REGULATORY INFORMATION DISTRIBUTION SYSTEM (RIDS)

PG&E Letter DCL-98-153

Docket No. 50-275, OL-DPR-80
Docket No. 50-323, OL-DPR-82
Diablo Canyon Units 1 and 2
License Amendment Request 98-08
Revision of Technical Specification 3/4.3.2 to Change First and Second Level
Undervoltage Relay Setpoints and Surveillance Frequencies

**REVISION OF TECHNICAL SPECIFICATION 3/4.3.2
TO CHANGE FIRST AND SECOND LEVEL UNDERVOLTAGE RELAY SETPOINTS
AND SURVEILLANCE FREQUENCY**

Figure 2 - Existing FLUR Setpoints

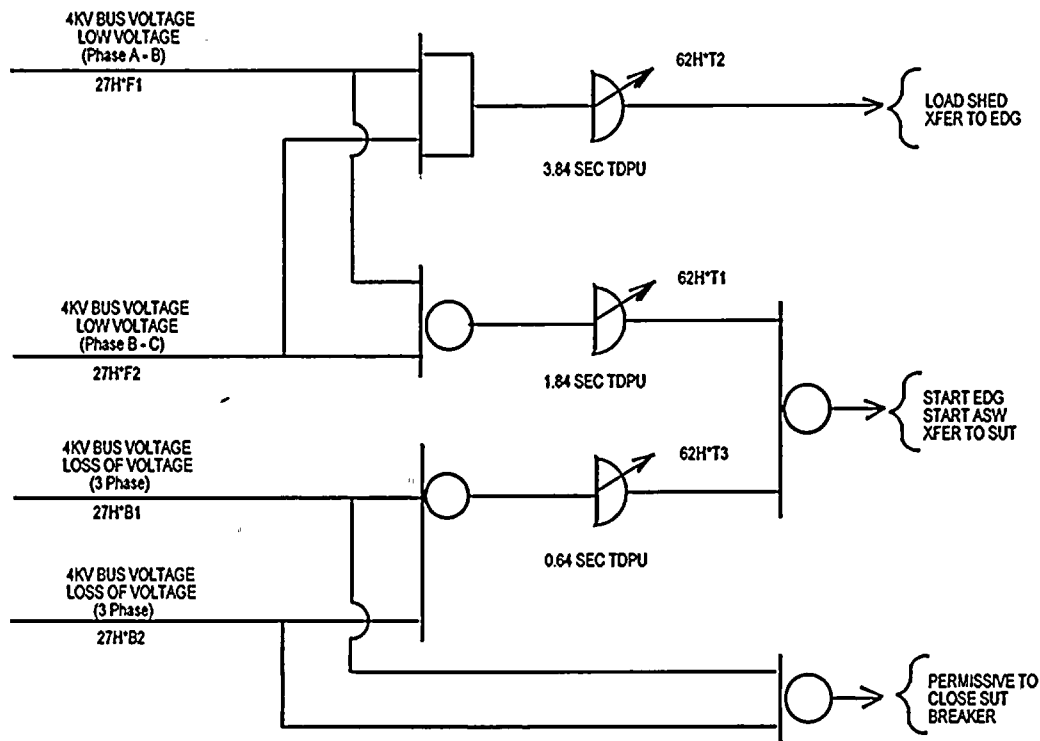
The second FLUR load shed relay is an instantaneous relay with no time delay. The TS value for the relay is to drop out at not less than 2870 volts. Refer to Figure 2 for a time voltage plot for the existing FLUR relays. It shows the inverse time relation for the two FLURs with time delays.

Figures 2, 3, and 4 document that the proposed design will start the EDG as fast as the existing design for a complete loss of power. For voltages greater than zero, the proposed design will operate as fast, or faster, over most of the voltage range, than the existing design. The proposed design meets all of the acceptance criteria discussed above and will ensure continued compliance with GDC-17 and the intent of BTP PSB-1.

Figure 3 - Proposed FLUR Logic

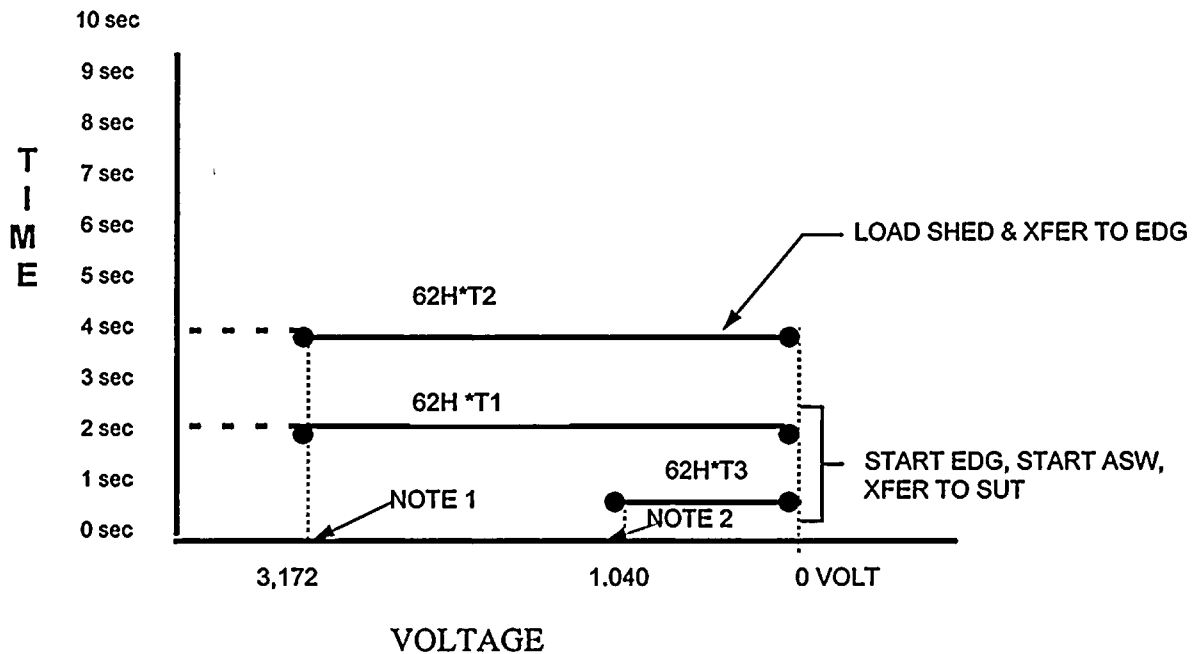
To meet the acceptance criteria discussed earlier, it will be necessary to modify the FLUR design. The proposed design incorporates fixed setpoint undervoltage relays with solid state digital timers. The relays and timers are capable of being set to specific voltages and time delays. The proposed design uses four instantaneous undervoltage relays combined with three timers to provide the first level undervoltage protection that is required to meet the acceptance criteria. Figure 3 shows the proposed FLUR logic and Figure 4 shows the time voltage plot of the proposed FLUR setpoints. The proposed TS setpoints for the FLUR voltage relays and the FLUR timers are listed below. (Relay device identification numbers shown below are for identification of relays on Figure 2. The "*" is used in place of letters F, G, and H, for each of the three 4 kV buses, which are identical.)

1. RELAYS 27H*F1 AND 27H*F2 ARE INSTANTANEOUS RELAYS. THE PROPOSED RELAY DROP OUT SETPOINT IS 3,172 VOLTS
2. RELAYS 27H*B1 AND 27H*B2 ARE INSTANTANEOUS RELAYS. THE PROPOSED RELAY DROP OUT SETPOINT IS 1,040 VOLTS
3. THE PROPOSED DESIGN USES RELAYS 27H*B1 AND 27H*B2 TO PROVIDE THE LOSS OF VOLTAGE FUNCTION. EXISTING RELAY 27H*B1 FUNCTIONS AS A PERMISSIVE TO CLOSE THE SUT BREAKER ON AUTOMATIC BUS TRANSFER WHEN THE BUS RESIDUAL VOLTAGE IS ABOUT 25% OF 4KV. PROPOSED DESIGN USES ITS SPARE CONTACT TO PROVIDE THE ADDITIONAL LOSS OF VOLTAGE FUNCTION.
4. WHEN THE FLUR UNDERVOLTAGE RELAY INHERENT DELAY OF 0.05 SEC. IS INCLUDED, THE TECHNICAL SPECIFICATION TRIP SETPOINT FOR THE TIME DELAY FUNCTION ARE OBTAINED.

FLUR VOLTAGE RELAYS PROPOSED TS VALUES		
VOLTAGE RELAYS	TRIP SETPOINT	ALLOWABLE VALUE
Load Shed & Start EDG (27H*F1)	3172 volts	3126 to 3218 volts

Load Shed & Start EDG (27H*F2)	3172 volts	3126 to 3218 volts
Start EDG (27H*B1)	1040 volts	≥ 993 volts
Start EDG (27H*B2)	1040 volts	≥ 993 volts

FLUR TIMERS PROPOSED TS VALUES		
TIMER RELAYS	TRIP SETPOINT ¹	ALLOWABLE VALUE
Start EDG Function (62H*T1)	1.89 seconds	≤ 1.95 sec.
Load Shed Function(62H*T2)	3.89 seconds	3.83 to 3.95 sec.
Start EDG Function(62H*T3)	0.69 seconds	≤ 0.75 sec.
